25 November 2021

Our Ref: 20037, Rev. 1

### Application to Amend Planning Permit PA1900722 35 Ervins Road, Nhill (formerly 239 Nhill-Harrow Road, Nhill)

## Proposed Site Plan

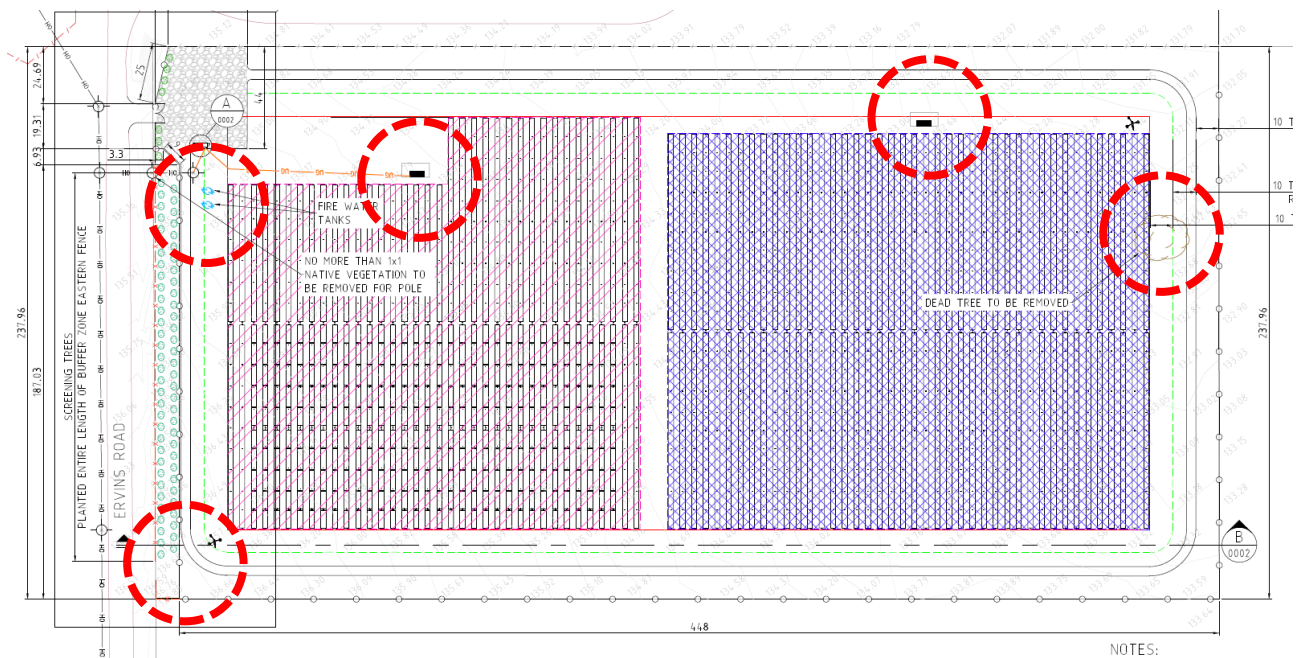
- Axis of arrays to be relocated from east-west to north-south
  - Decrease to the number of solar panels from 15184 to 10973 panels due to larger panel wattage and single axis tracking system
- Removal of southern access/crossover to Ervins Road.
- Removal of 4m-wide formed perimeter track.
  - Informal vehicle tracks within the 10m perimeter firebreak to be retained.
- Relocation of both inverters to the northern side of the facility
- Provision of a two (2) permanent 22,500 litre water tanks:
  - One (1) for a static water supply for firefighting purposes
  - One (1) tank for irrigation purposes for proposed landscaping

Key changes outlined in red circles (excluding solar array realignment)
